Project  
**Extension for a Cinema  
Market Place Shopping Centre  
Bolton, BL1 2AL**

Drawing Title  
**Proposed First Floor Plan**

Project No.	Drawing No.	Revision
0091	-A-PL-07	A
Scale @ A1	Drawn By	
1:200	XT

**1** PROPOSED FIRST FLOOR PLAN  
SCALE 1:200

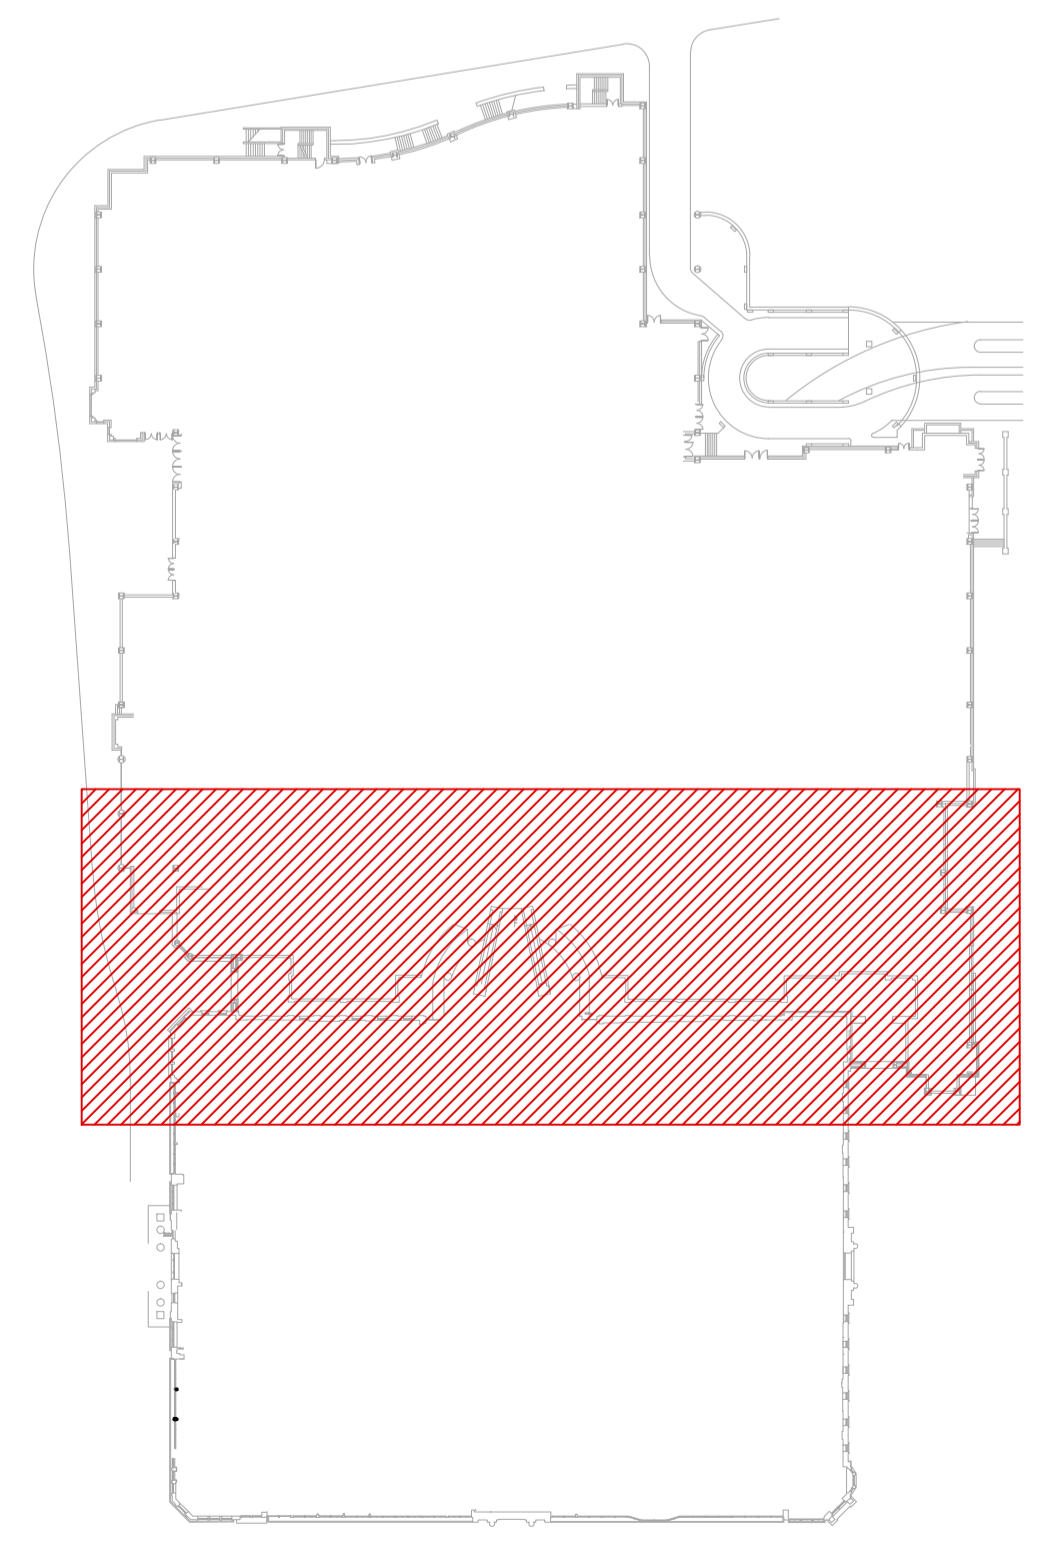
- REV A NOTES:**
- Glass box added to first floor plan
  - Escalator layout updated
